CONNECTION ASSESSMENT & APPROVAL PROCESS ASSESSMENT SUMMARY

Project: Ramore TS – Build New 115-27.6kV Station

CAA ID: 2002-EX059

Date: August 23, 2002

Figure 1

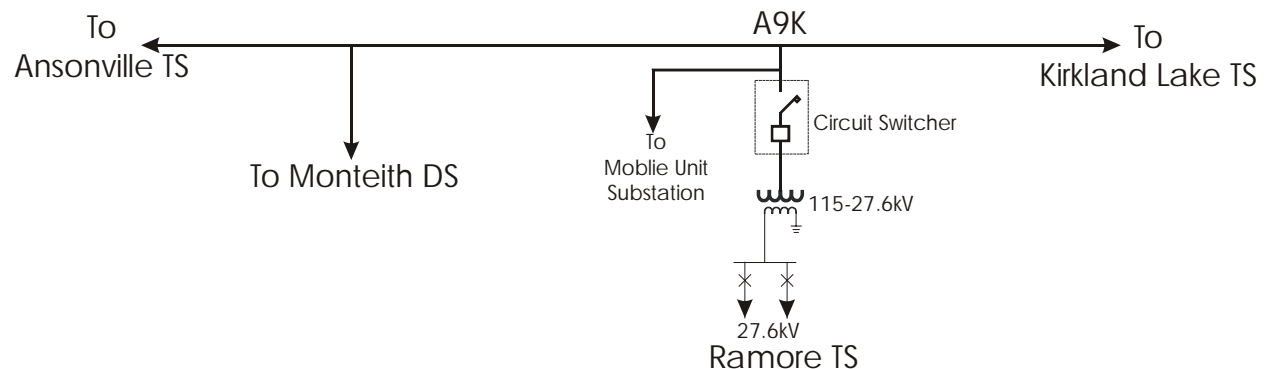
The existing facilities at Ramore TS have deteriorated to a state that it is more economical to replace them than to refurbish the facilities. The applicant is proposing to replace the existing Ramore TS with a new station having a maximum capacity of 16.7MVA, which is twice the current station capacity of 8MVA. The Ansonville TS to Kirkland Lake TS 115kV transmission circuit A9K has a summer thermal capacity of 270A (54MVA @ 115kV) and a winter capacity of 370A (74MVA @ 115kV). The circuit has enough capacity to support the new higher capacity Ramore TS.

The new transformer impedance is about 8.72% on 10MVA base and is about 20% lower than the impedance of the existing transformer (11.13% on 10MVA base). The short circuit levels at Ramore TS, Ansonville TS, and Kirkland Lake TS will increase slightly. The current short circuit levels at Ramore TS 115kV and 27.6kV buses are about 3500A and 2200A respectively. The short circuit interrupting capabilities of the new Ramore TS, Ansonville TS, and Kirkland Lake TS are well above the expected short circuit levels in the area.

The addition of circuit switcher as the high voltage interrupting device is an improvement in the isolation of Ramore TS station fault over the existing arrangement of relying on coverage provided by A9K line protection.

There is no under frequency load shedding (UFLS) scheme at the existing Ramore TS and HONI is not proposing to install any UFLS at the new station. It has been decided that UFLS is not required at Ramore TS at this time. IMO periodically review the UFLS requirements in the system and will inform HONI if in the future it is deemed necessary to have UFLS at Ramore TS.

This proposal is essentially a like-for-like replacement of existing facilities and will have no adverse impact on the IMO controlled grid.

Based on the above assessment, it is recommended that a Notification of Approval for this proposal be issued to the applicant.
